Principal Planning Report

JRPP Number	2011SYW087
Application Number	DA-1210/2011
Proposed Development	Demolition of existing structures and construction of a residential flat building comprising fifty-three (53) residential units and two levels of basement car parking with vehicular access to be provided from Campbell Street and associated landscaping and service features.
Property Description	Part Lot 1 DP 1053951, Part Lot 2 1053951 93-95 Campbell Street Liverpool NSW 2170
Applicant	Gelder Architects
Land Owner	Talbus Pty Ltd
Capital Investment Value	\$11,000,000
Recommendation	Refusal

LIVERPOOL CITY COUNCIL DESIGN REVIEW PANEL ASSESSMENT REPORT

Figure 4: Flood Map indicating medium risk flood impact to subject site

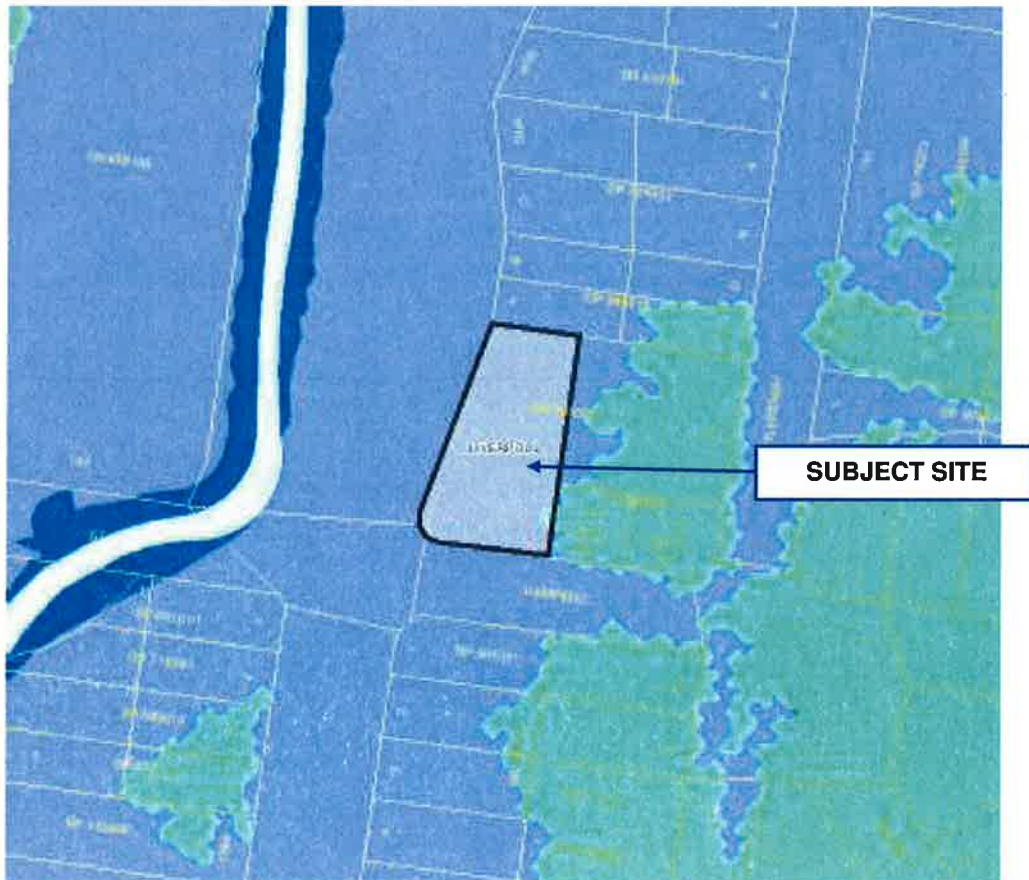
The site is however flood liable and there has not been satisfactory assessment on flood dynamics or on residential safety.

Site Plan

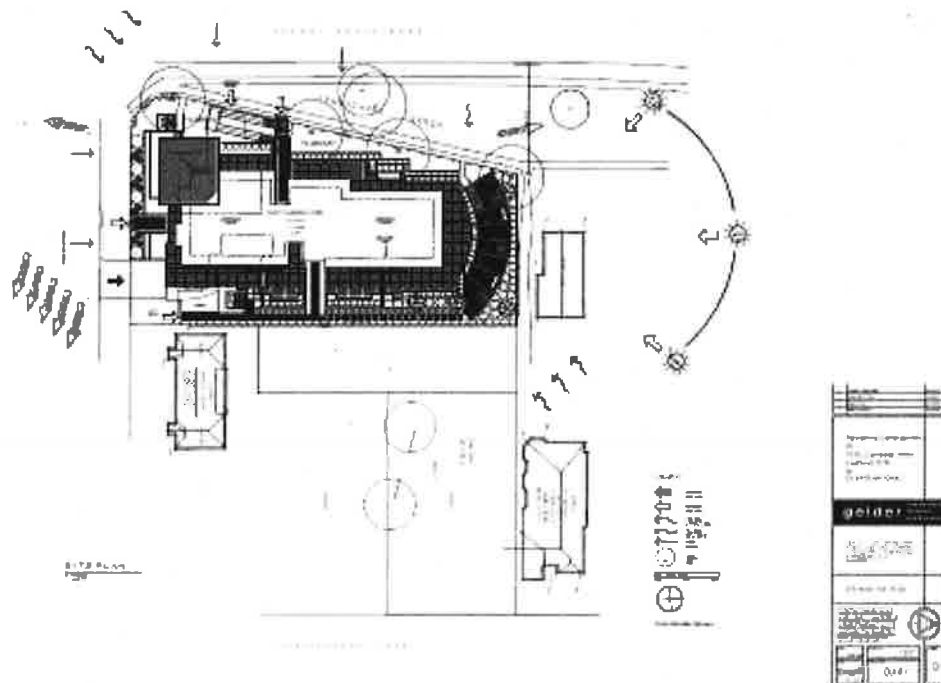
1. *Siting and footprint*
 - *Setbacks to Copeland Street are approximately 50% of the 8m which was a strategic urban design requirement for all properties that face the City-centre ring road*

- *The Panel has not been persuaded that extent of the proposed non-compliance is justified, or that compliance with the DCP's setback control is either unnecessary or unwarranted*

- *The non-compliant street setback results in an excessively-large building footprint which compromises opportunities for perimeter landscaping and the provision of effective communal areas outdoors*

Landscape Plan

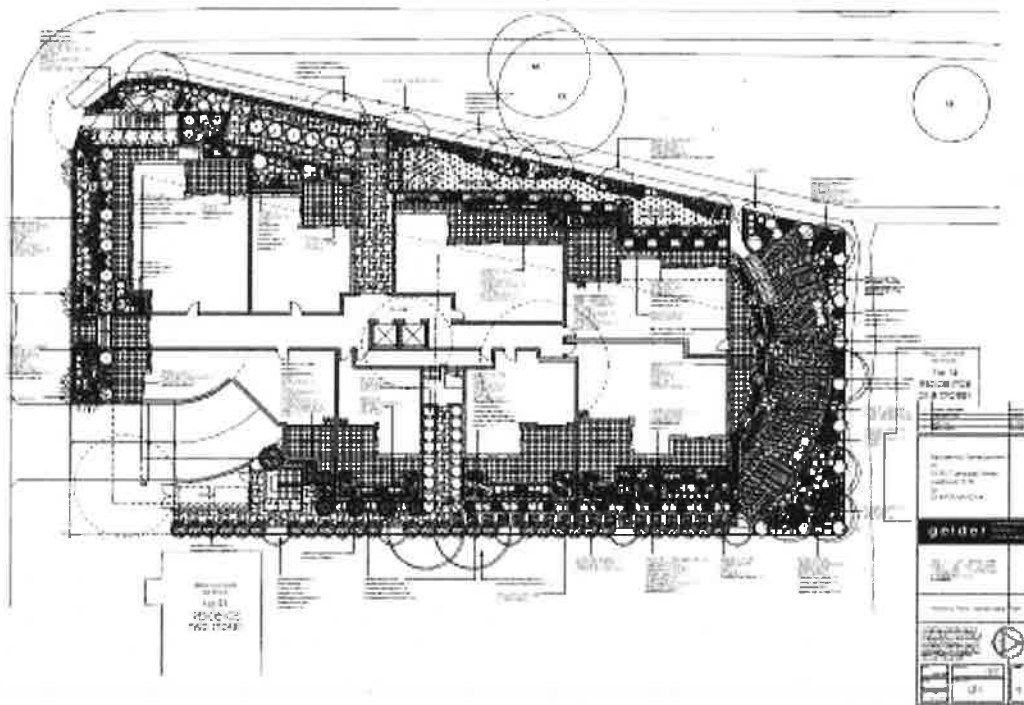
- There are inconsistencies between the architectural plans and landscape concept design.
- The architectural plans are not accompanied by furniture room layouts, particularly given the room sizes and dimensions.
- The landscape plan needs to be developed further.
- The proposal does not provide for an appropriate mix of units in relation to their sizes and number of bedrooms. This is inconsistent with the design principles within SEPP 65 and Council's DCP (DCP 2008 Part 4).
- The proposal does not have a 'designed' area for communal open space for the prospective residents.
